11, 13, 15, 17, 19, 21 and 23 Hollis Street – Official Plan Amendment and Zoning By-law Amendment Applications – Request for Direction Report

Date: January 4, 2023

From: Director, Community Planning, Etobicoke York District

Planning Application Number: 21 177934 WET 05 OZ

Attachment 5: Site Plan

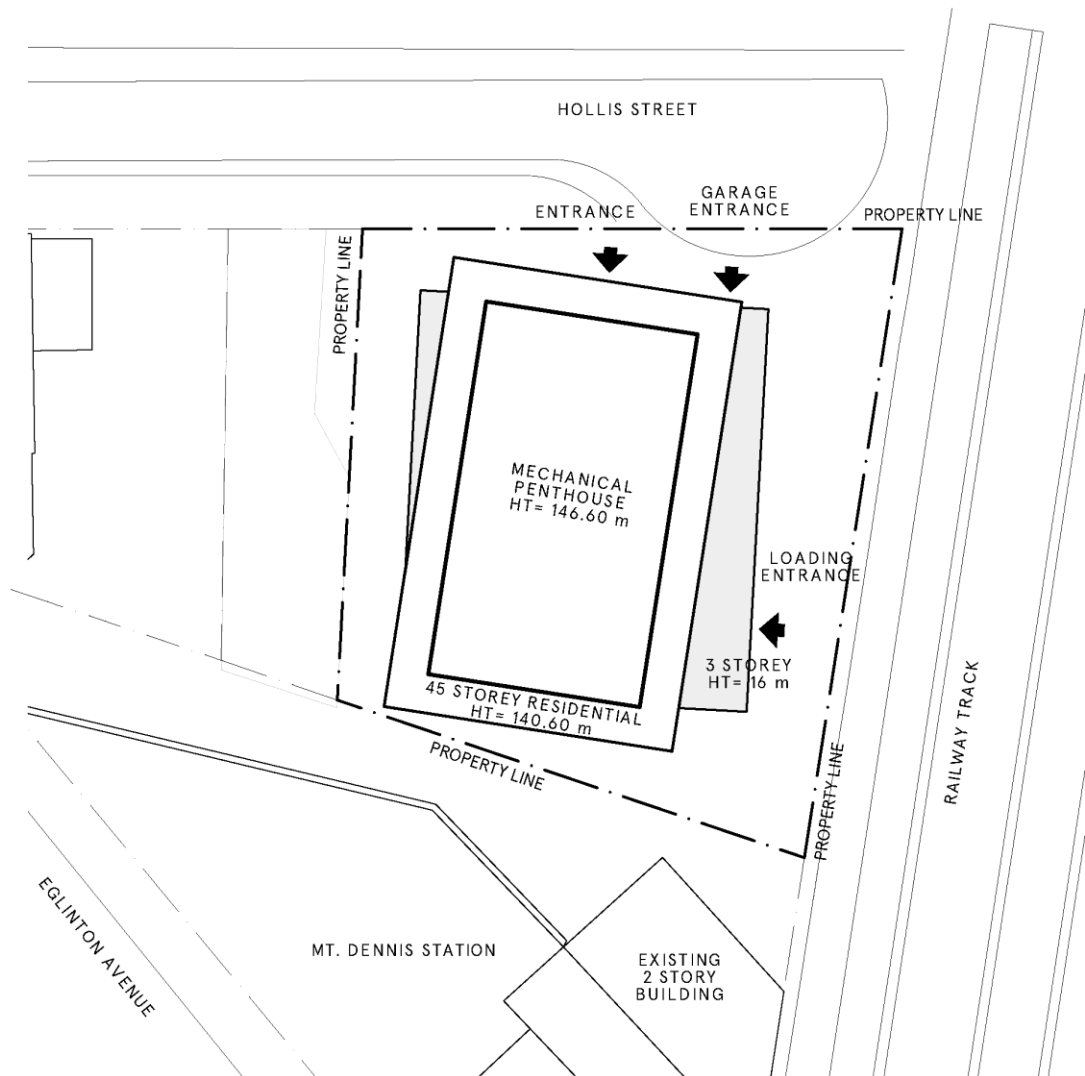
The application proposes a base building of three storeys in height, however, the a tower element overhangs the base building by approximately 1.3 metres to the southwest, along Hollis Street, and approximately 3.4 metres to the north east. The base building is proposed to have a rear yard setback of 2.3 metres. In its current form the base building does not fit harmoniously with the existing or planned context of Hollis Street, does not conform with the policies of the Official Plan, the Council-adopted Mount Dennis Secondary Plan and does not follow the direction of the Tall Building Design Guidelines.

for development of a tall building. The Mount Dennis Secondary Plan identifies tall to tall built form transition as being achieved through the application of separation distance, orientation of the tower portions of the buildings and building setbacks. The Plan identifies a minimum tower separation distance of between 25 metres to 30 metres, requiring minimum tower setbacks of between 12.5 metres to 15 metres. The application proposes tower setbacks between 2.5 metres to 6.5 metres to the east.

Vehicular access to the site is proposed via a driveway to run perpendicular to Hollis Street at the northwest corner of the property. The applicant proposes to reconfigure the terminus of Hollis Street into a new partial cul-de-sac, part of which would be located on the northwest corner of the subject site. The full cul-de-sac would be completed with the redevelopment of the properties on the east side of Hollis Street if/when an application is submitted. Transportation Services staff requested additional information and revisions to the proposed cul-de-sac.

Although no road widening is required, the applicant has been required to reconfigure the terminus of Hollis Street into a new partial cul-de-sac, partially located on the northwest corner of the site. The lands required for the cul-de-sac are required to be conveyed to the City with this application. The applicant is required to revise their plans to show the conveyance. Additionally, Transportation Services staff have requested revisions to the proposed sidewalk and cul-de-sac design.

The existing streetscape includes a 1.5-metre sidewalk and five street trees along the Hollis Street right-of-way which are proposed to be removed. The proposal would result in a boulevard width of approximately 11.1 metres along Hollis Street at the widest point, but is constrained to less than 6.0 metres adjacent to the cul-de-sac area. Two new street trees are proposed along with a 2.1-metre wide sidewalk. Additional opportunities for street tree planting are sought to achieve Toronto Green Standard requirements through increased building setbacks.

- c. The owner has submitted revised drawings illustrating the conveyance of lands required for the cul-de-sac satisfactory to the General Manager, Transportation Services and the Chief Planner and Executive Director, City Planning;
